RE: Broken Arrow Investments, LLC – Derr Pit – Technical Revision No. 8 Adequacy Review 2 Response – File No. M-2008-017

Broken Arrow Investments, LLC has received the Division's Adequacy Review 2 of the Technical Revision No. 8 Request letter dated April 19, 2023. Below are the comments and the corresponding responses that we have provided to address the comments.

Adequacy Review 2 Comments

JT-Derr 2020 Red Of:

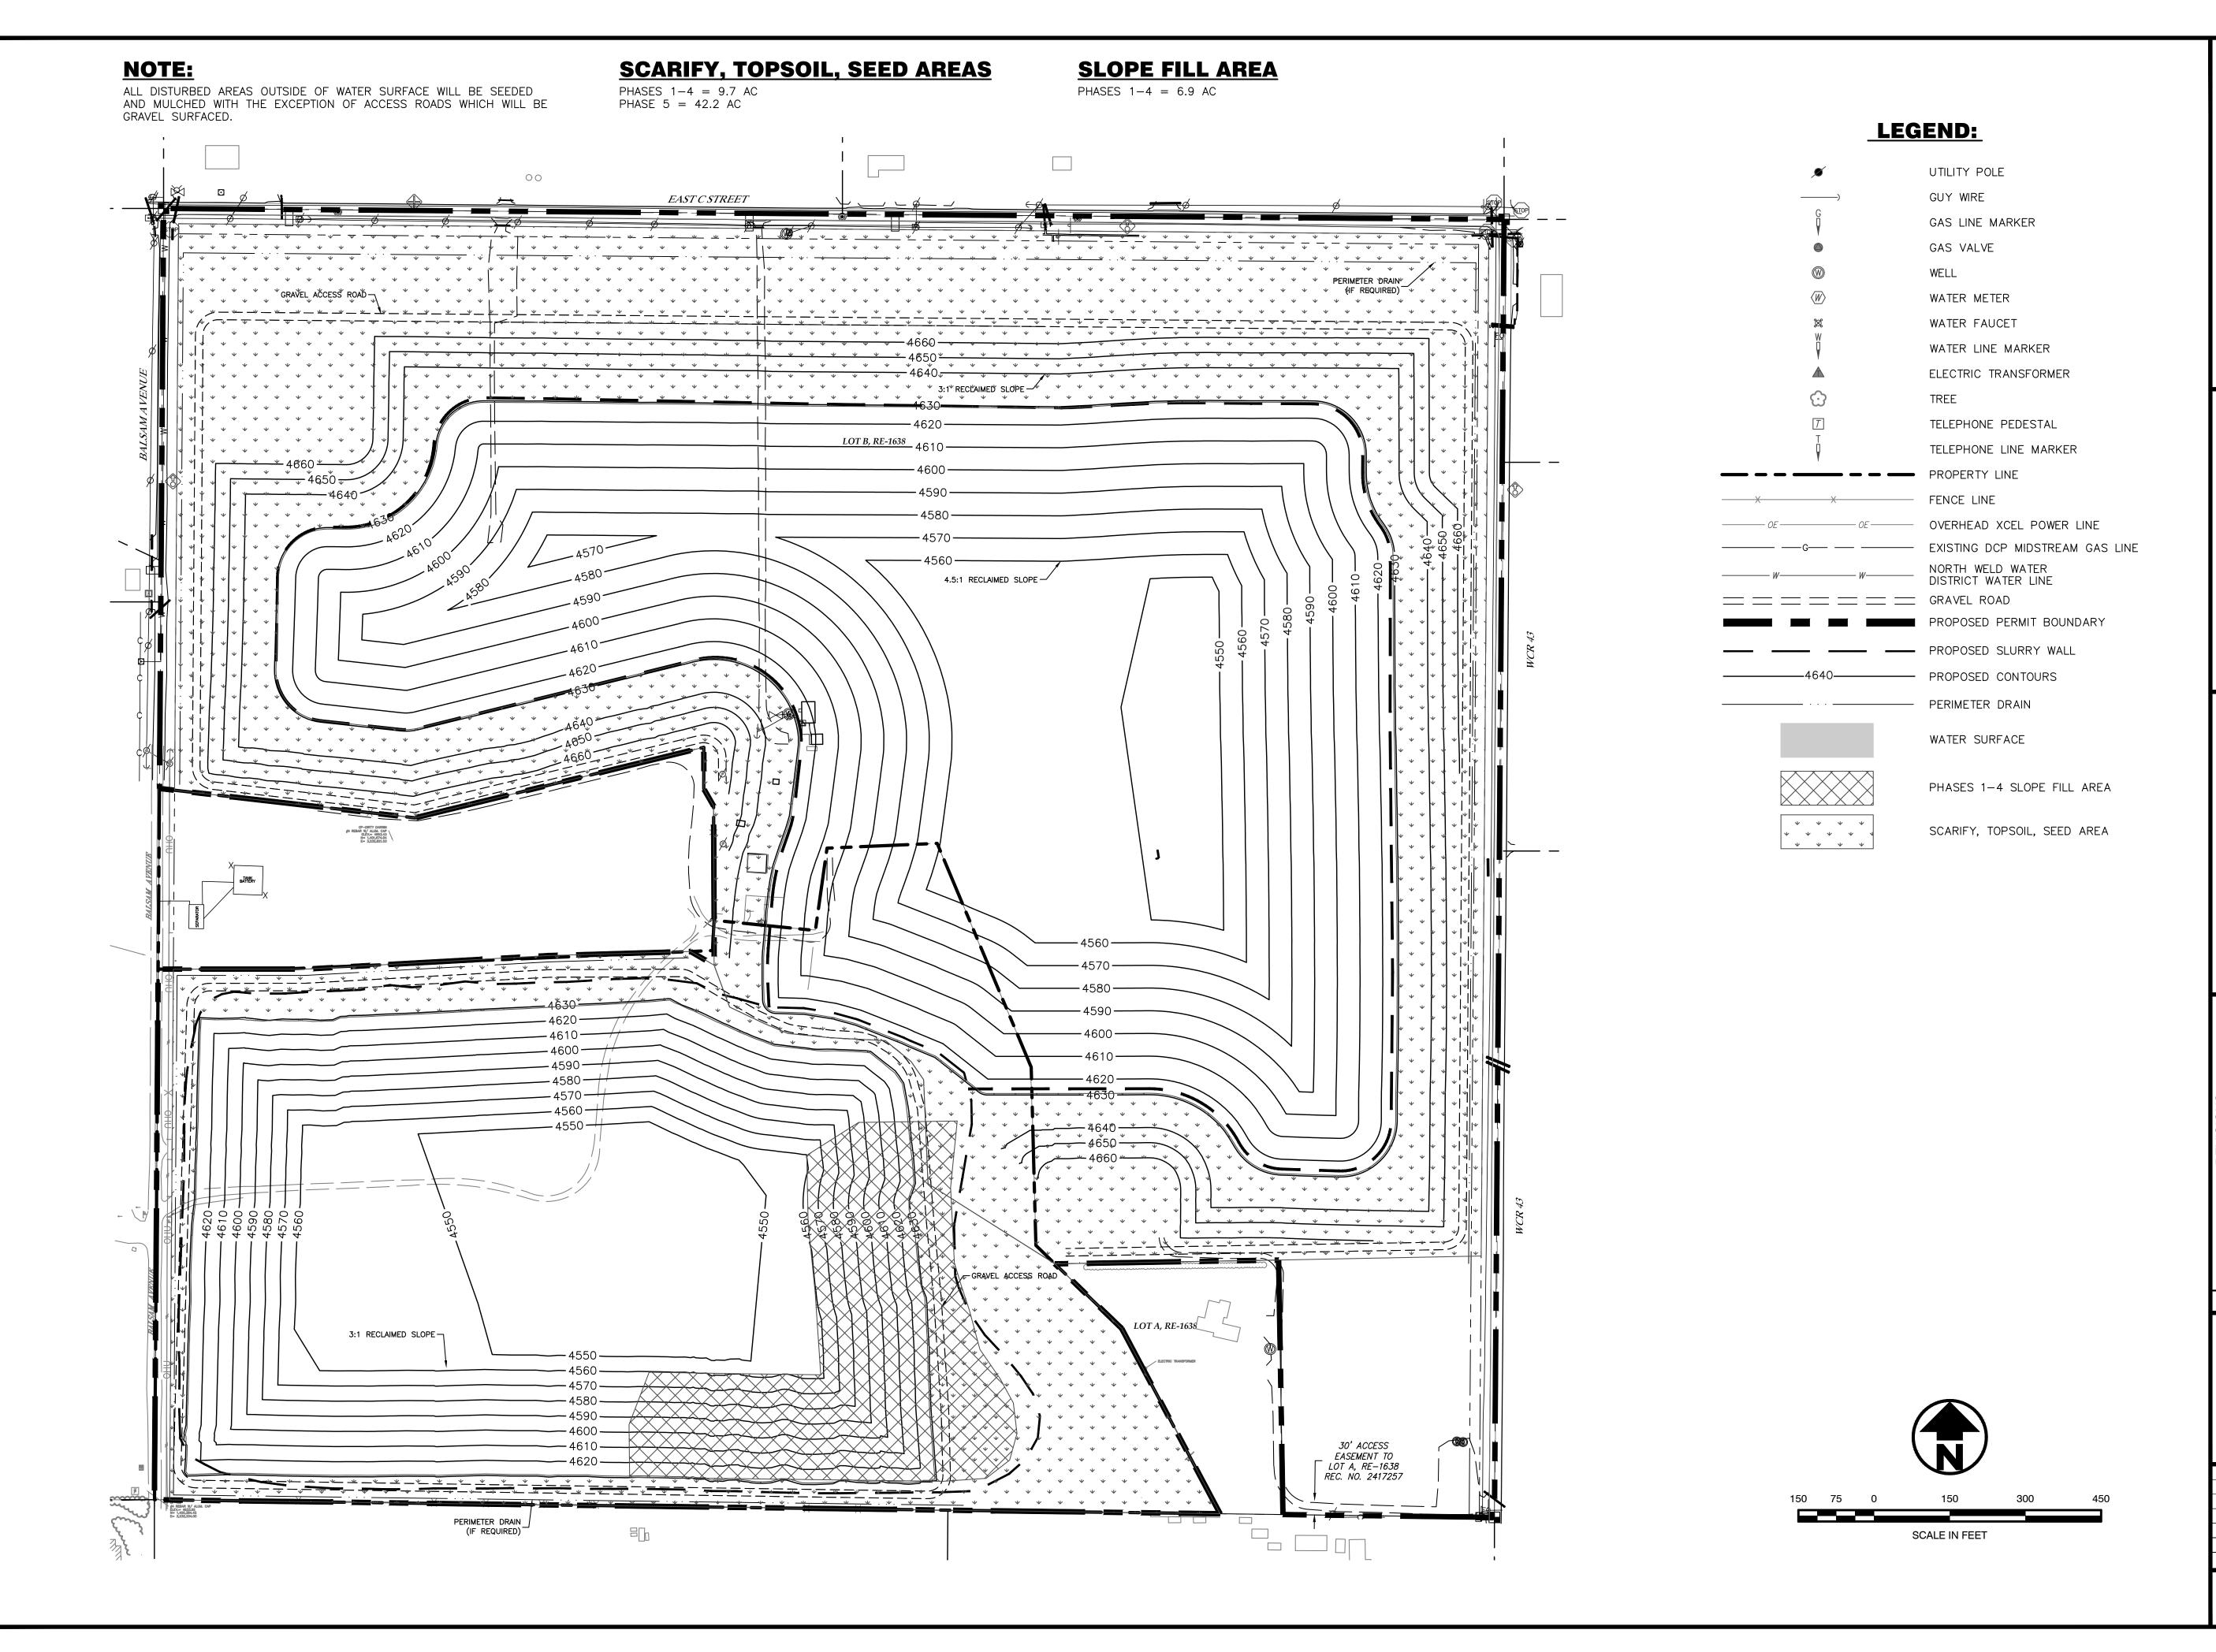
- 3. Please provide a reclamation plan map(s) that illustrates the following tasks by area:
 - a) Phases 1-4 acres where 6" topsoil will be replaced, scarified, and revegetated, including area of reservoir above proposed waterline. (CIRCES software calculates revegetation cost based on acres, seed mix, tilling, mulch/fertilizer, and anticipated failure/re-seed rate)
 - b) Phases 1-4 acres of 3:1 interior slope that will need to be compacted and graded below waterline.
 - c) Phase 5 perimeter acres that will need to have topsoil replaced, graded and seeded above water line. DRMS assumes that the entire area within Phase 5a will need to have topsoil replaced and reseeded for bonding purposes.

Response: An updated Reclamation Plan Map has been provided with the attachments

to this letter providing the location of acres where the 6" topsoil will be replaced, scarified and revegetated, Phases 1-4 acres of 3:1 interior slope that will need to be compacted and graded, and Phase 5 perimeter acres that will need to have topsoil replaced, graded and seeded. Acknowledged that Phase 5a area bonding is for all area to be re-seeded.
